Proposal: Alexandria Park Community School
Redevelopment (SSD 17_8373)

SUBMISSION
ALEXANDRIA PARK COMMUNITY SCHOOL REDEVELOPMENT (SSD 17_8373)

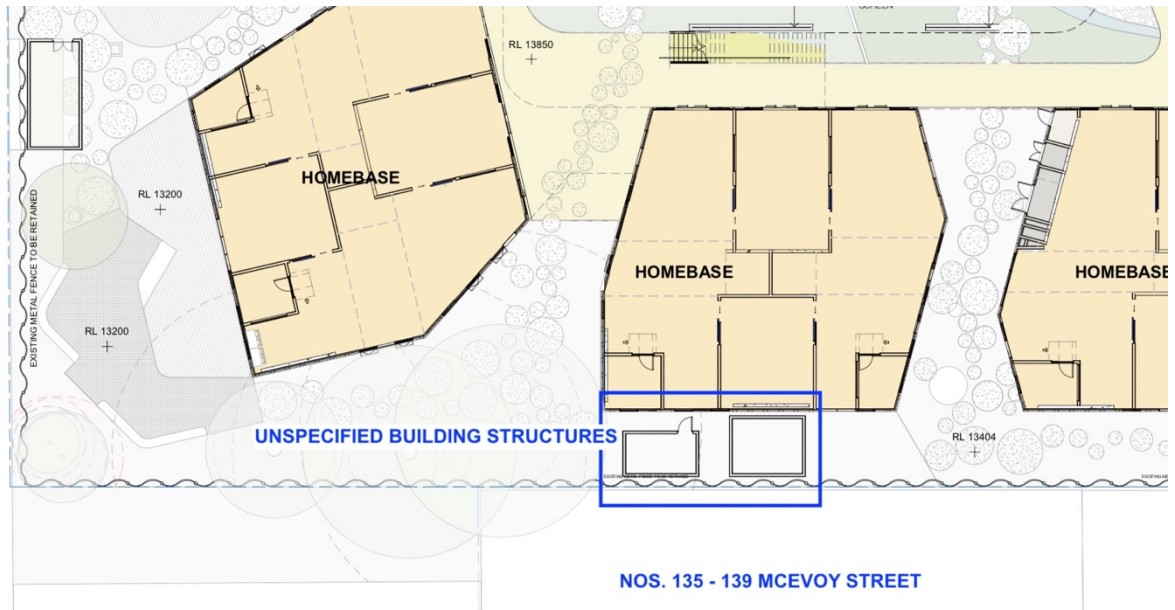
As suggested previously, the principle concern for the owner of Nos. 135 – 139 McEvoy Street is for the scale of development adjacent the common boundary, its impacts upon the development potential of the site and upon the amenity of future occupants. The planning principle in *The Benevolent Society* requires that in areas undergoing change, the impact on what is likely to be built on adjoining sites should be considered as well as the existing development. But whilst these concerns are mentioned, there is no quantitative analysis of the impacts of the proposed breach to the building height upon potential residential properties to the south and east of the site.

No analysis has been undertaken to understand the difference between a ‘compliant’ building form and the building form proposed.

Residential flat development to 4 storeys in height is permitted adjacent the site’s southern boundary, with habitable rooms setback a minimum 6 metres from the common boundary – see Objective 3F-1 of the Apartment Design Guide. The Guide suggests that adequate building separation distances should be shared equitably between neighbouring sites, to achieve reasonable levels of external and internal visual privacy. The design guidance also notes that for residential buildings next to commercial buildings, separation distances to commercial buildings should use the same habitable room distances.

As a consequence, concern is raised in relation to the proposal’s failure to achieve a 6 metre separation to the common boundary and to comply with the prescribed building height limit. The resultant impact may either lead to a reduction in the development potential of Nos. 135 – 139 McEvoy Street, or to a loss of amenity and sunlight to the units and their private outdoor spaces at the lower levels of any future development.

It is alternatively suggested that the proponent reposition the 'Homebase' modules for the primary school to ensure a minimum 6 metre landscaped setback to the common boundary, and modify the setback of the rooftop structure to ensure no greater overshadowing impact than a building otherwise compliant with a 6 metre setback and a maximum 15 metre building height.

1 GROUND FLOOR PLAN
1 : 200

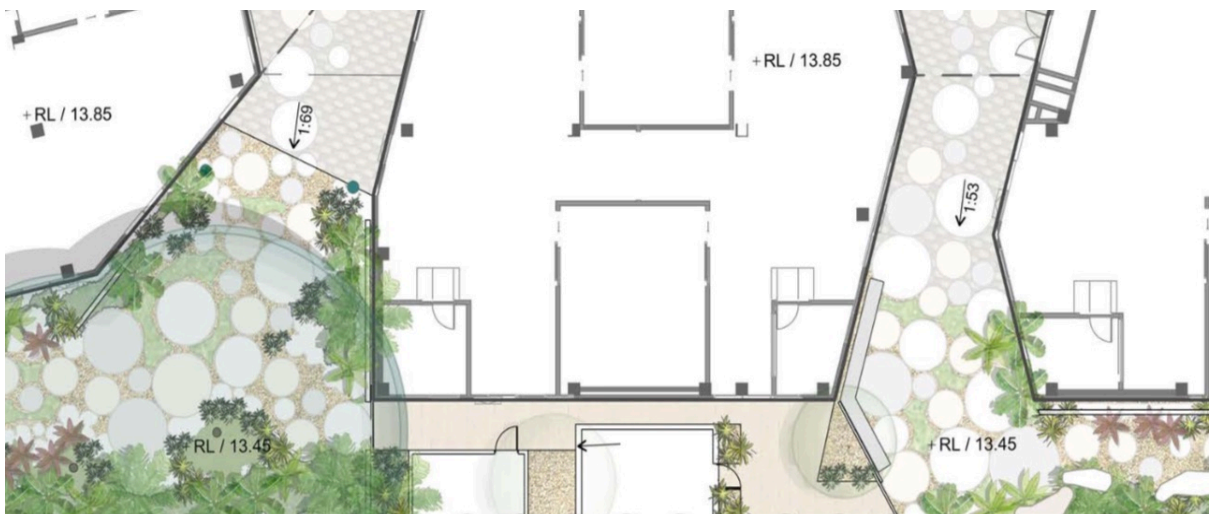
It is noted there are 2 x unspecified building structures located immediately adjacent to our boundary (see figure below extracted from the Architectural Drawings). These structures are not labelled upon the floor plan, nor represented in sections or elevations. It is therefore difficult to determine their impacts upon Nos. 135 – 139 McEvoy Street. They do however significantly reduce the ability for the available setback area to be utilised for landscaping in scale with the proposed development, and as a consequence, further exacerbate issues in relation to the proposed 'Homebase' building's height and setback from the common boundary.

Some form of landscaping must be introduced adjacent the common boundary to assist in reducing the scale of intended development, and to assist providing an appropriate green buffer and visual privacy between the adjacent land uses.
